HISTORIC AND DESIGN REVIEW COMMISSION

June 04, 2025

HDRC CASE NO: 2025-090
ADDRESS: 910 E SOUTHCROSS BLVD
LEGAL DESCRIPTION: NCB 7665 LOT SW 200 OF 4 & NE IRR 118.4 OF SW IRR 233. 4 OF C & W IRR 93 OF 15
ZONING: I-1, H
CITY COUNCIL DIST.: 3
DISTRICT: Mission Historic District
APPLICANT: Edward Hernandez/Nirvana Architecture Studio
OWNER: Isarael Ramirez/LIDS CHRISTIAN CENTER INC
TYPE OF WORK: New Construction of 10,000 sf church
APPLICATION RECEIVED: April 9, 2025
60-DAY REVIEW: June 8, 2025
CASE MANAGER: Caitlin Brown-Clancy

The applicant is requesting a Certificate of Appropriateness for approval to construct a new 10,000 sf building housing an auditorium, classrooms, and various auxiliary spaces on the existing campus of LIDS Christian Center at 910 E Southcross Blvd and site work consisting of a master parking and landscaping plan.

1 SITE PLAN

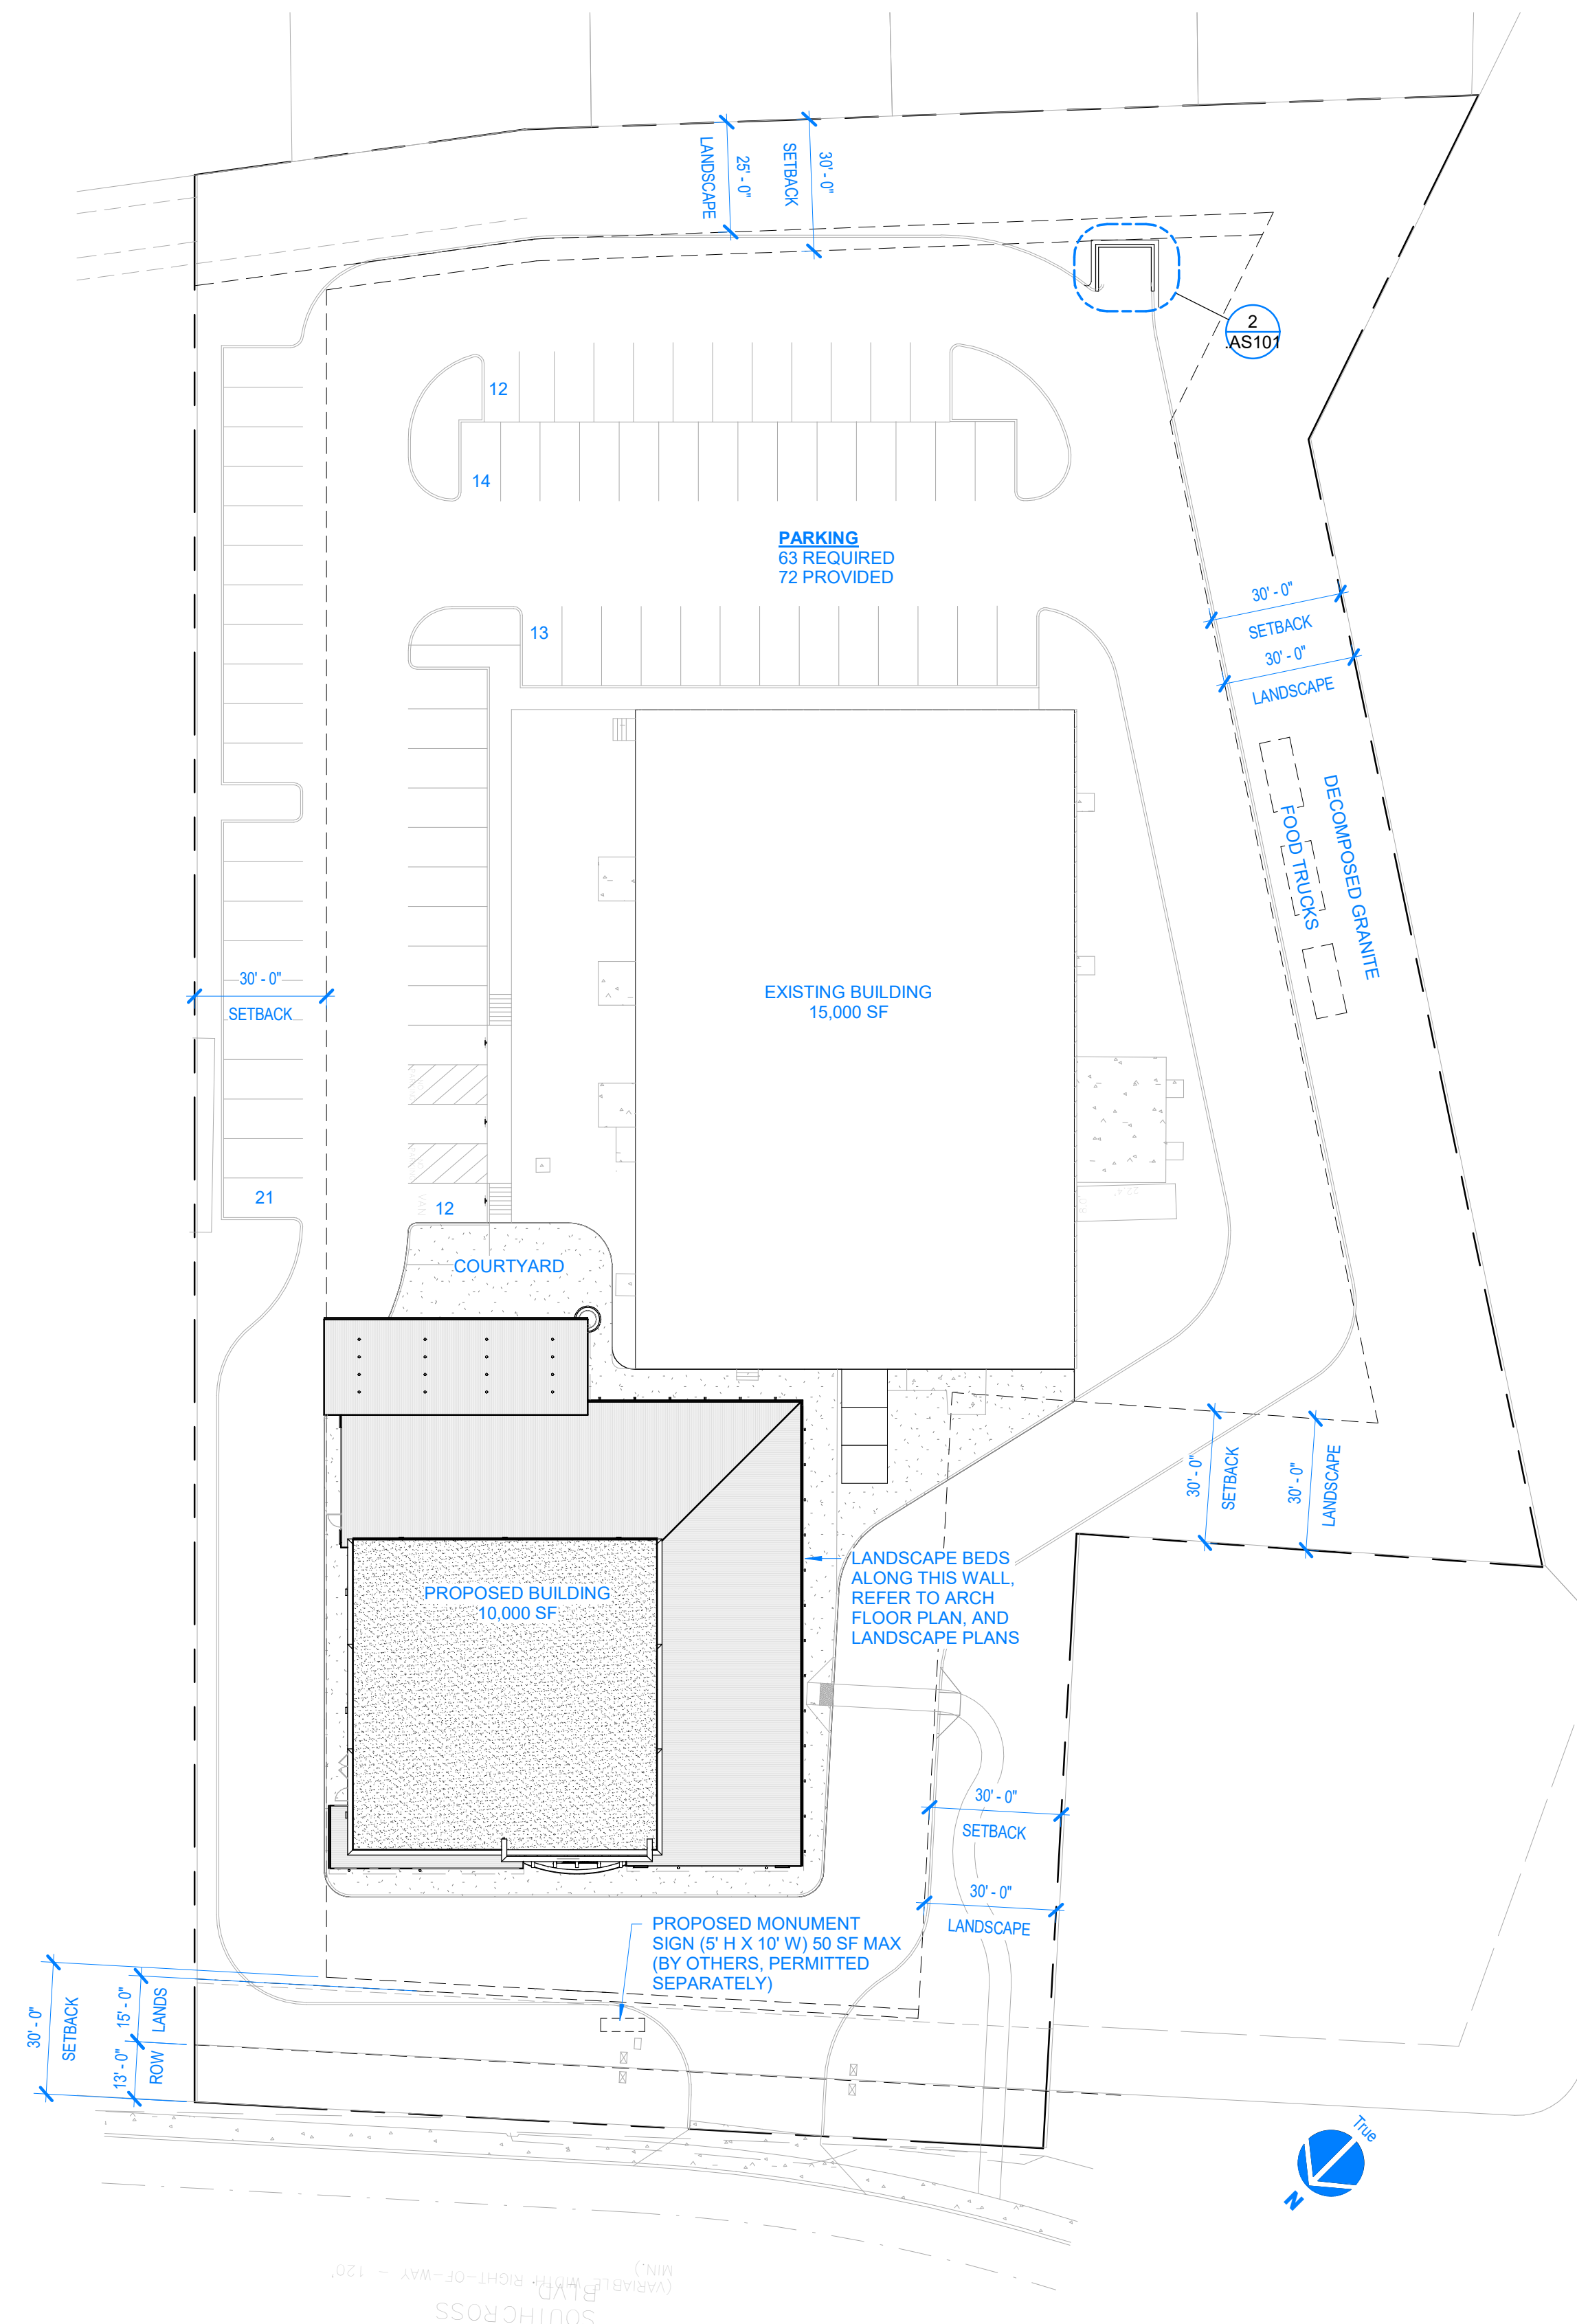
- f. **SITE DEVELOPMENT (SETBACK)** – The applicant has not indicated the exact setback depth, however, plans indicate a set back of approx. 60'0". Guideline 3.A.v states that on corridors where building setbacks vary or are not well-defined by existing contributing buildings, buildings should maintain a minimum front setback of 15' for properties north of SE Military. Staff finds the applicant should submit a dimensioned site plan indicating all setbacks prior to returning to the HRDC for final approval.

- g. **SITE DEVELOPMENT (PARKING)** – The applicant is requesting to introduce parking at the rear and Eastern side of the lot which accommodates 72 spaces. Guideline 3.A.vi states that Rear / side parking is encouraged north of SE Military Drive. Staff find the proposed parking plan appropriate.

- h. **SITE DEVELOPMENT (VEHICULAR ACCESS)** – The applicant has proposed one main driveway into the property that splits into two that circumnavigate the existing and new structures leading to the rear parking lot. Currently, the applicant has not indicated the width of the proposed drive and approach. Guideline 3.A.vii states that, in general, driveway widths should not exceed 24'. Staff finds the applicant should submit a dimensioned site plan indicating driveway and approach dimensions prior to returning to the HRDC for final approval.

- n. **LANDSCAPE** – The applicant has submitted a conceptual landscaping plan that features a 30'0" wide landscaping buffer on the N, S, and W property lines to include unspecified trees, low plantings, and decomposed granite. Additionally, the site features a few water features at the new construction and unspecified trees throughout the parking lot. Guideline 3.V.iii calls for parking areas to be screened from the sidewalk and street with landscaping to allow a filtered view of the parking area while reducing its overall visual impact. Additionally, Guideline 3.v.i states that canopy trees shall be integrated into the design of surface parking lots to provide shade for a minimum of 25 percent of any individual parking lot. Generally, staff finds the proposed landscaping plan to be appropriate but finds the applicant should submit a final landscaping plan indicating plant and tree species and material specifications that are consistent with the Guideline for review prior to returning to the HDRC for final approval.

Staff recommends approval to construct a new 10,000 sf building housing an auditorium, classrooms, and various auxiliary spaces on the existing campus of LIDS Christian Center at 910 E Southcross Blvd and site work consisting of a master parking and landscaping plan with the following stipulation;

1 ROOF PLAN

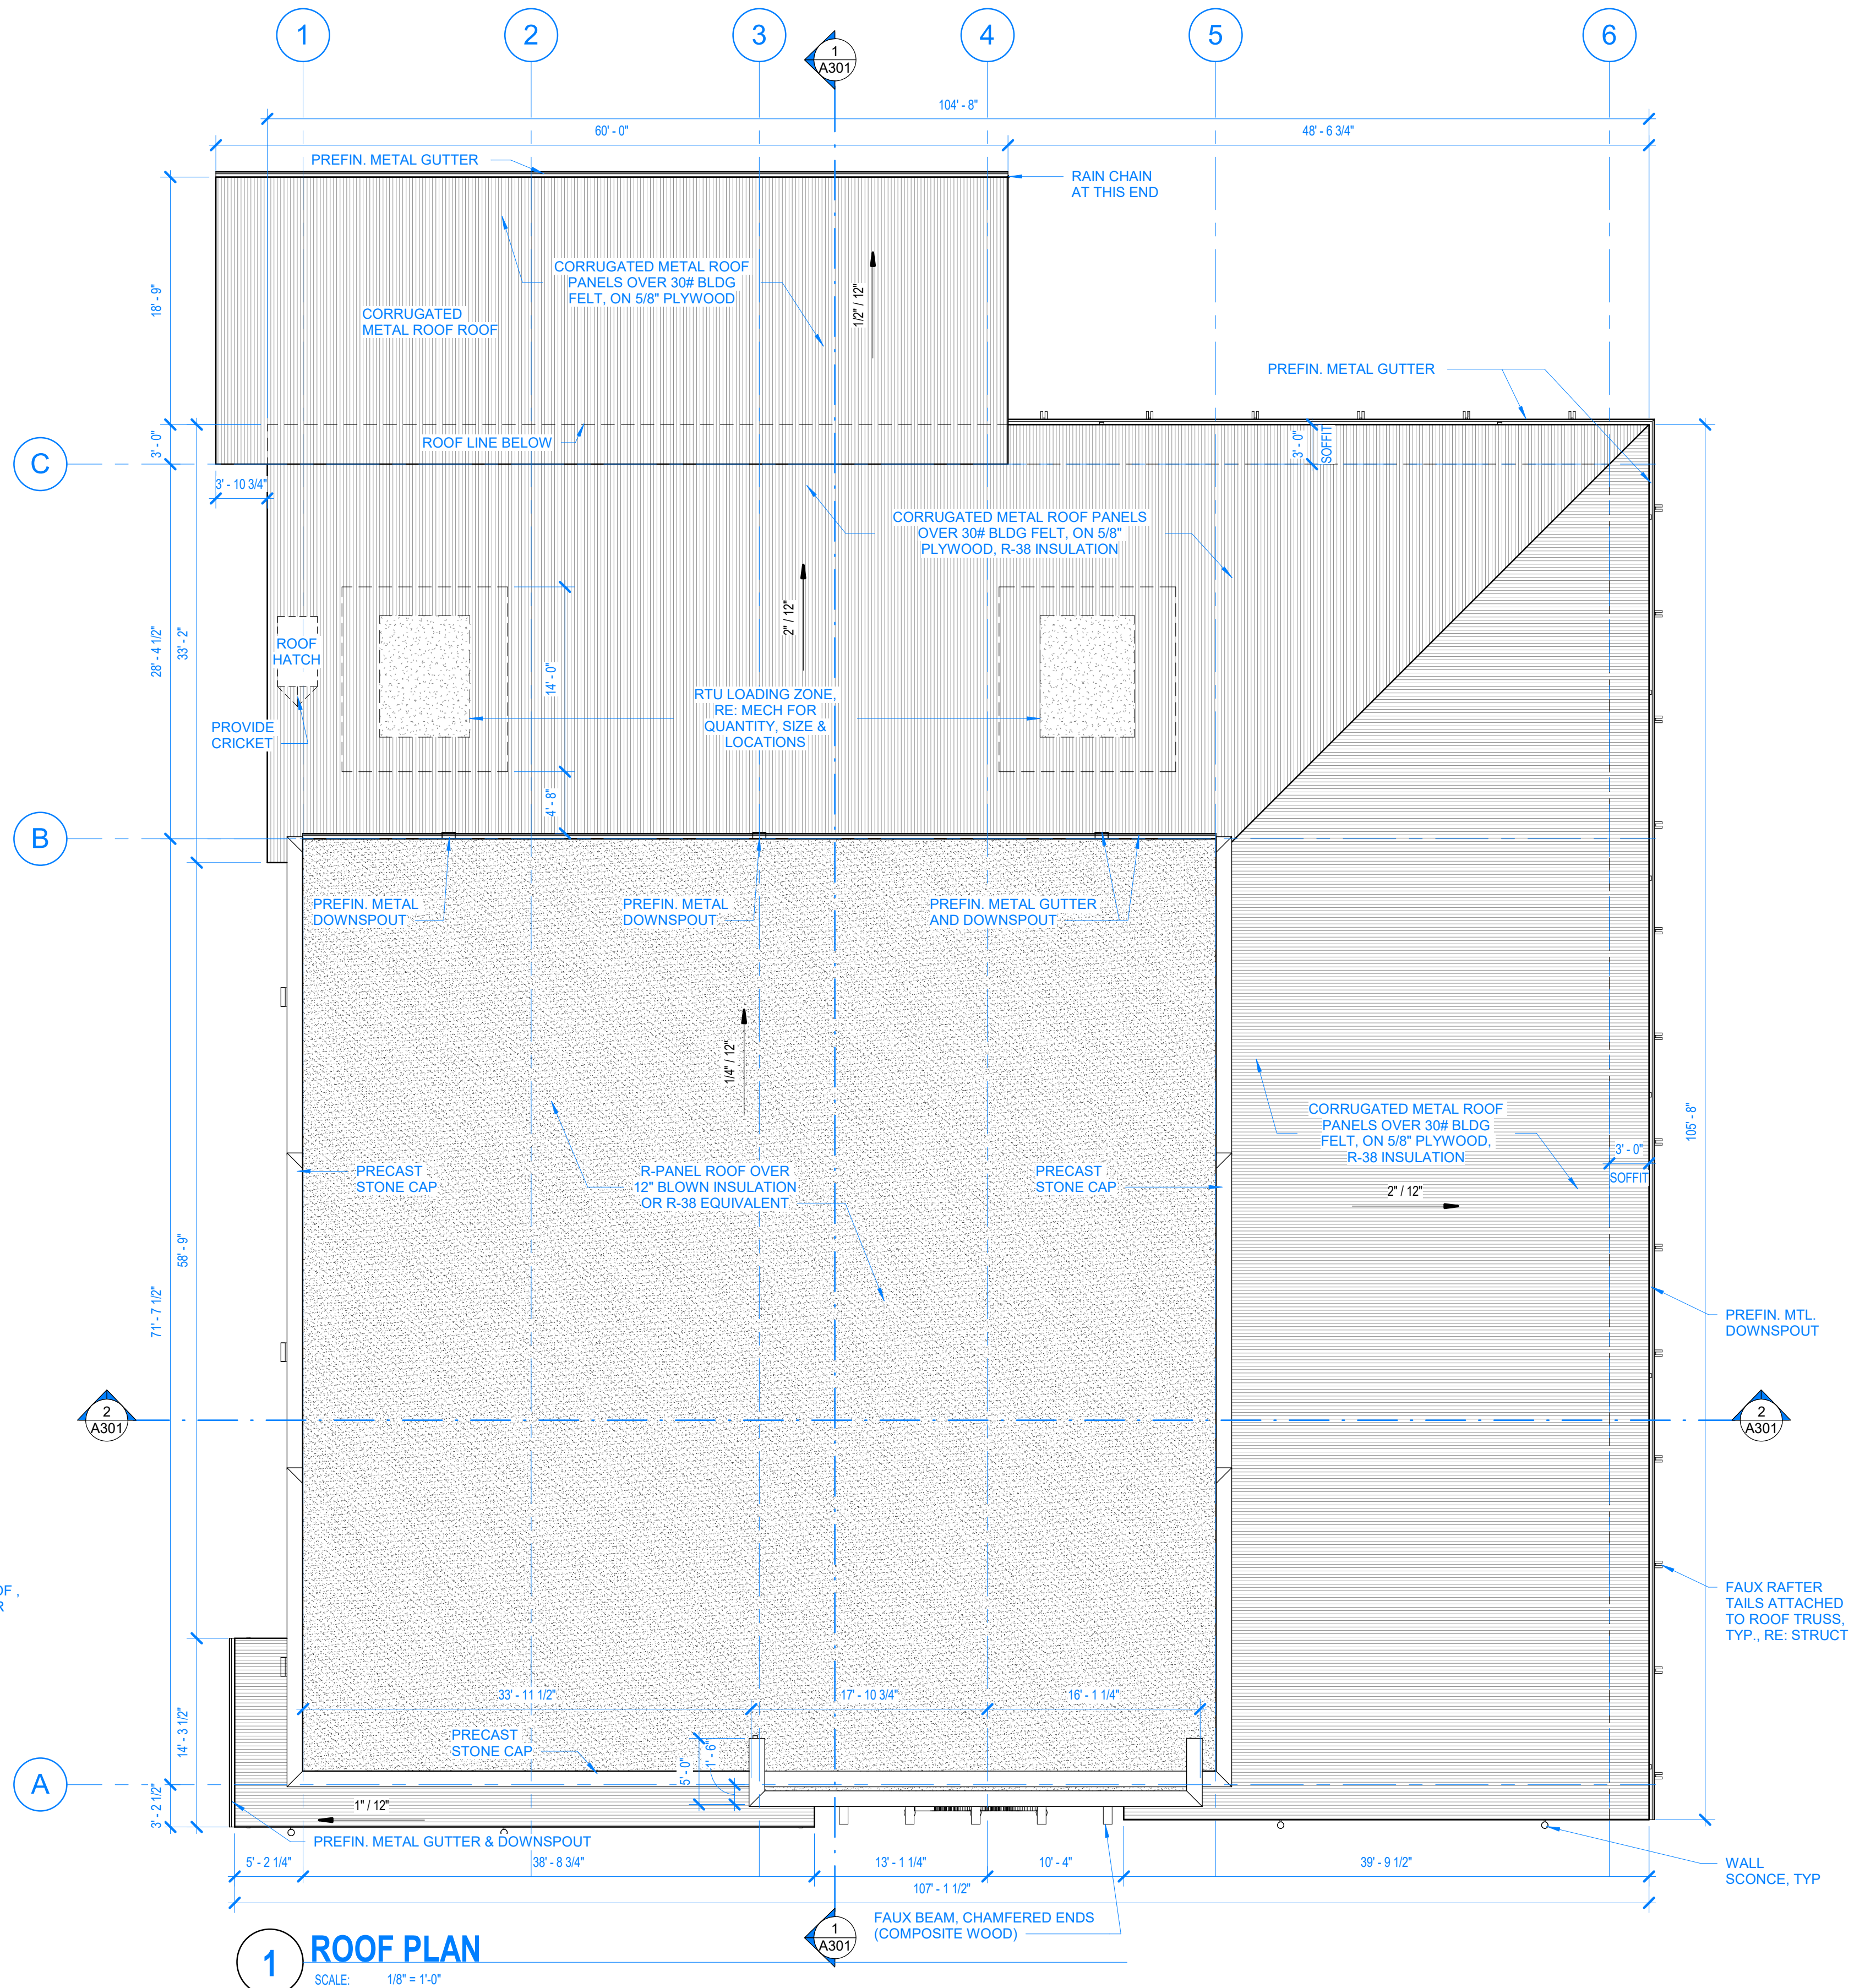
- j. **ROOF FORM** – The applicant has proposed a primary form consisting of a flat roof with a parapet wall punctuated by a taller parapet which projects 4'0" above the aforementioned flat roof with parapet. This central form is flanked on either side by a secondary form to the West and a tertiary form to the East both of which feature a shed roof form. Guidelines 3.C.i and ii state that a flat roof with a parapet wall is recommended as a primary roof form for all commercial buildings. Parapets may vary in height to articulate individual wall planes or programmatic elements such as entrances. Additionally, secondary roofs should utilize traditional forms such as a hip or gable and should establish a uniform language that is subordinate to the primary roof form. Contemporary shed roofs may be considered on a case-by-case basis as a secondary roof form based on the design merit of the overall proposal and the context of the site. Staff finds the proposed roof forms consistent with the Guidelines.
